REACTIVITY CONTROL SYSTEMS

3/4.1.3 MOVABLE CONTROL ASSEMBLIES

8610090135 861001  
PDR ADOCK 05000317  
P PDR

FIGURE 3.1-3  
ALLOWABLE TIME TO REALIGN CEA VERSUS  
INITIAL TOTAL INTEGRATED RADIAL PEAKING FACTOR

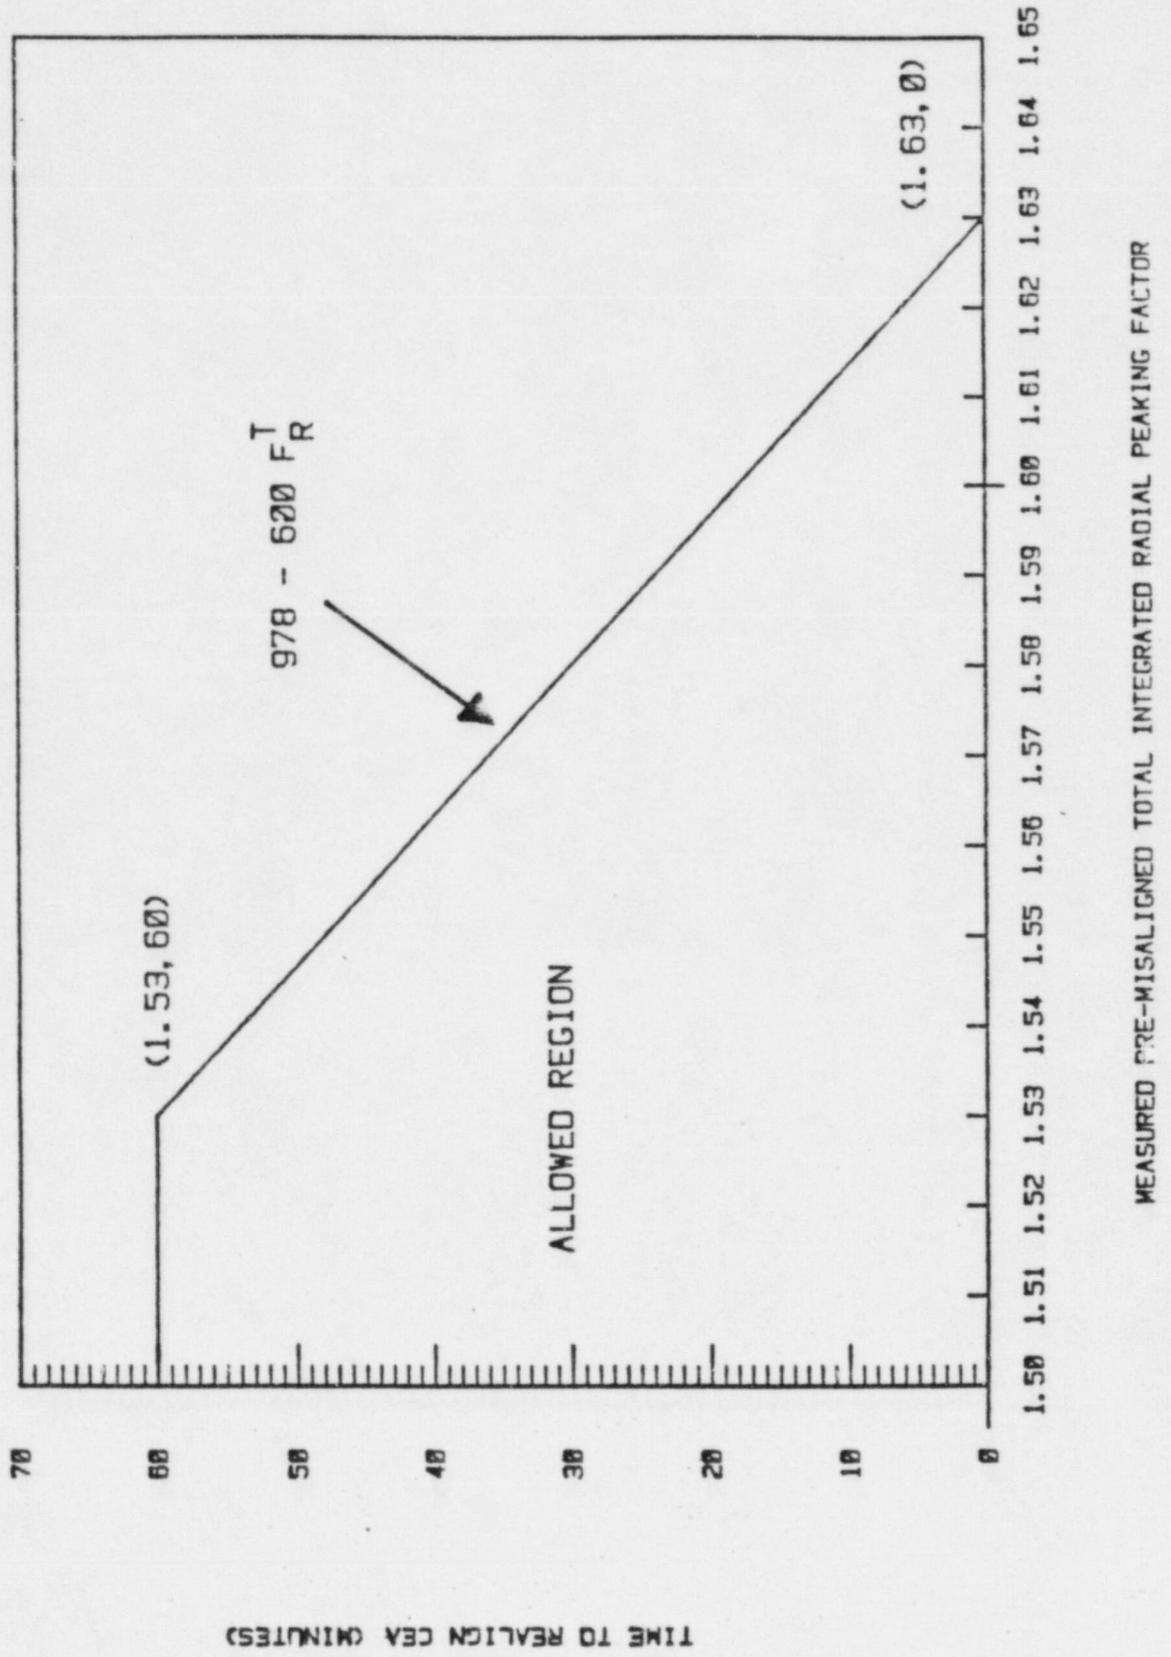
- f. With one CEA misaligned from any other CEA in its group by 15 inches or more, operation in MODES 1 and 2 may continue, provided that the misaligned CEA is positioned within 7.5 inches of the other CEAs in its group in accordance with the time allowance shown in Figure 3.1-3. The pre-misaligned  $F_r^T$  value used to determine the allowable time to realign the CEA from Figure 3.1-3 shall be the latest measurement taken within 5 days prior to the CEA misalignment. If no measurements were taken within 5 days prior to the misalignment, a pre-misaligned  $F_r^T$  of 1.65 shall be assumed.

- g. With one CEA misaligned from any other CEA in its group by 15 inches or more at the conclusion of the time allowance permitted in Figure 3.1-3, immediately start to implement the following actions:

- a) 50% of RATED THERMAL POWER
    - b) 75% of the THERMAL POWER level prior to the misalignmentwithin one hour after exceeding the time allowance permitted by Figure 3.1-3.

For a single CEA misalignment, the time allowance to realign the CEA (Figure 3.1-3) is permitted for the following reasons:

1. The margin calculations which support the power distribution LCOs for DNBR are based on a steady-state  $F_r^T$  as specified in Technical Specification 3.2.3.
2. When the actual  $F_r^T$  is less than the Technical Specification value, additional margin exists.
3. This additional margin can be credited to offset the increase in  $F_r^T$  with time that will occur following a CEA misalignment due to xenon redistribution.

The requirement to reduce power level after the time limit of Figure 3.1-3 is reached offsets the continuing increase in  $F_r^T$  that can occur due to xenon redistribution. A power reduction is not required below 50% power. Below 50% power there is sufficient conservatism in the DNB power distribution LCOs to completely offset any, or any additional, xenon redistribution effects.

FIGURE 3.1-3  
ALLOWABLE TIME TO REALIGN CEA VERSUS  
INITIAL TOTAL INTEGRATED RADIAL PEAKING FACTOR

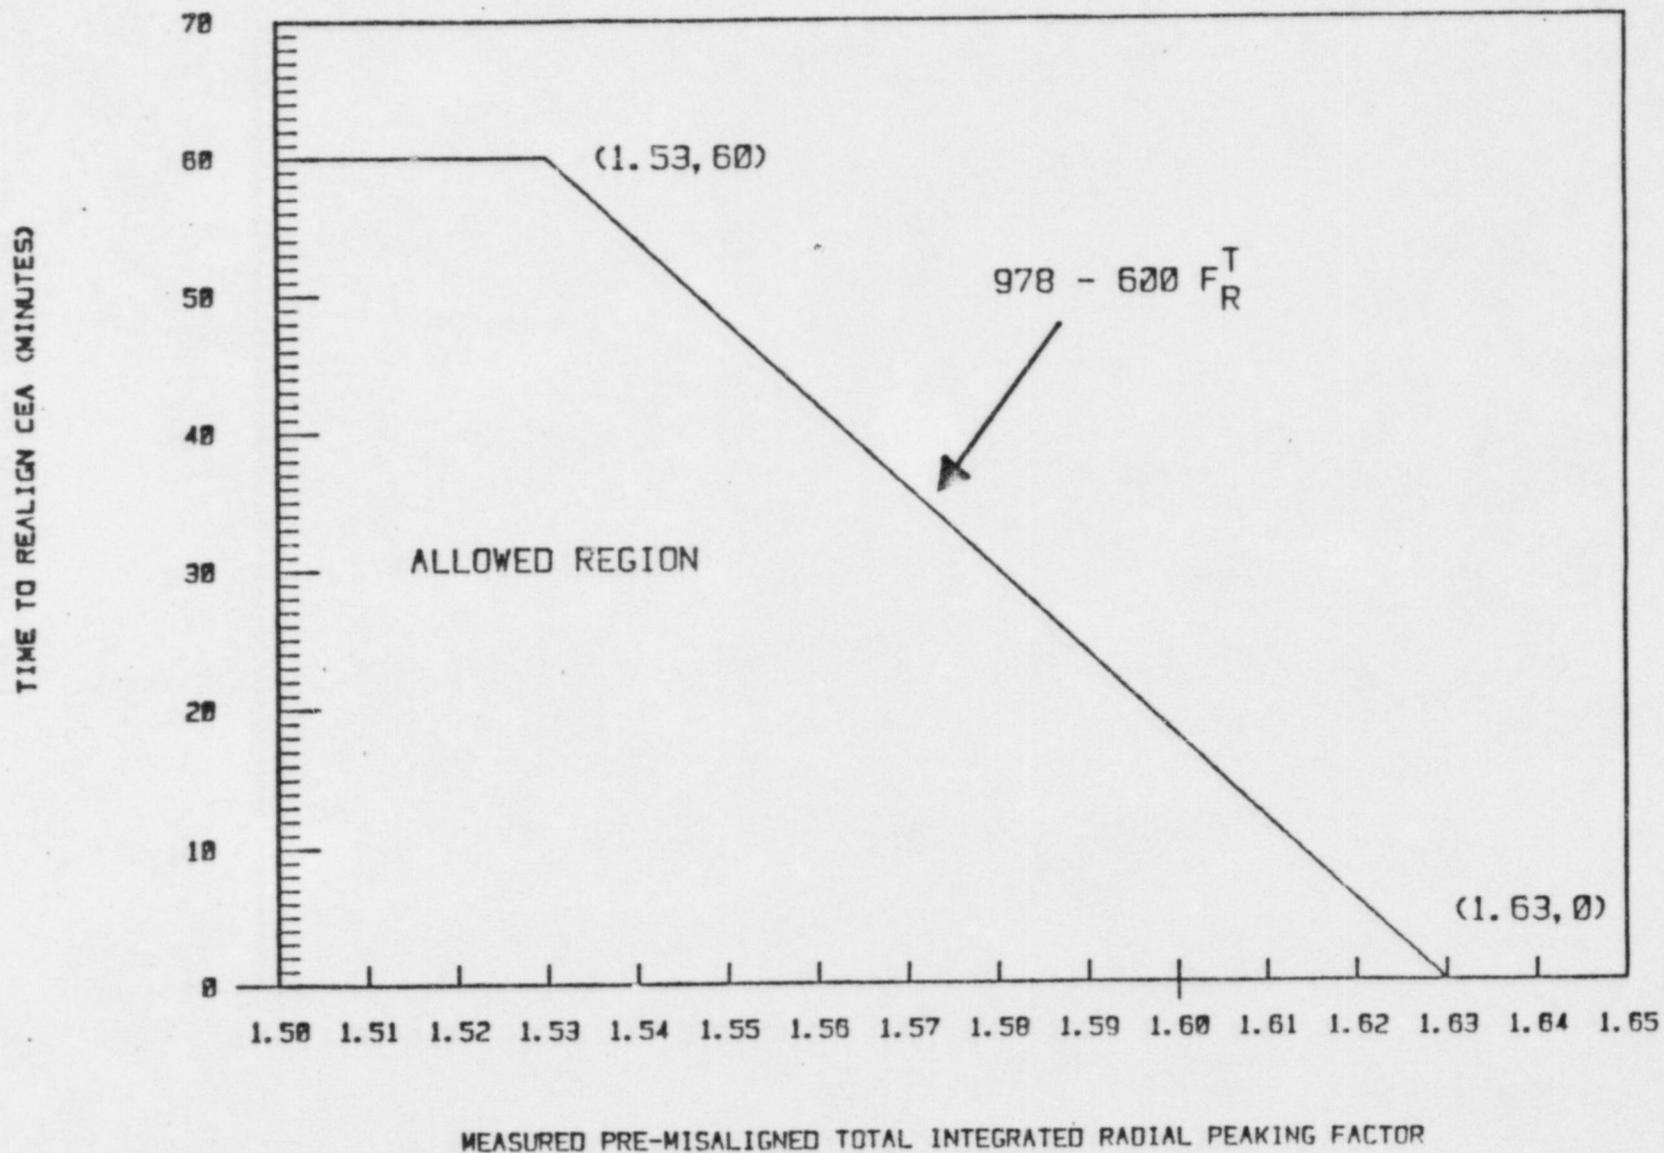
- f. With one CEA misaligned from any other CEA in its group by 15 inches or more, operation in MODES 1 and 2 may continue, provided that the misaligned CEA is positioned within 7.5 inches of the other CEAs in its group in accordance with the time allowance shown in Figure 3.1-3. The pre-misaligned  $F_r^T$  value used to determine the allowable time to realign the CEA from Figure 3.1-3 shall be the latest measurement taken within 5 days prior to the CEA misalignment. If no measurements were taken within 5 days prior to the misalignment, a pre-misaligned  $F_r^T$  of 1.65 shall be assumed.

- g. With one CEA misaligned from any other CEA in its group by 15 inches or more at the conclusion of the time allowance permitted in Figure 3.1-3, immediately start to implement the following actions:

- a) 50% of RATED THERMAL POWER
    - b) 75% of the THERMAL POWER level prior to the misalignmentwithin one hour after exceeding the time allowance permitted by Figure 3.1-3.

For a single CEA misalignment, the time allowance to realign the CEA (Figure 3.1-3) is permitted for the following reasons:

1. The margin calculations which support the power distribution LCOs for DNBR are based on a steady-state  $F_r^T$  as specified in Technical Specification 3.2.3.
2. When the actual  $F_r^T$  is less than the Technical Specification value, additional margin exists.
3. This additional margin can be credited to offset the increase in  $F_r^T$  with time that will occur following a CEA misalignment due to xenon redistribution.

The requirement to reduce power level after the time limit of Figure 3.1-3 is reached offsets the continuing increase in  $F_r^T$  that can occur due to xenon redistribution. A power reduction is not required below 50% power. Below 50% power there is sufficient conservatism in the DNB power distribution LCOs to completely offset any, or any additional, xenon redistribution effects.
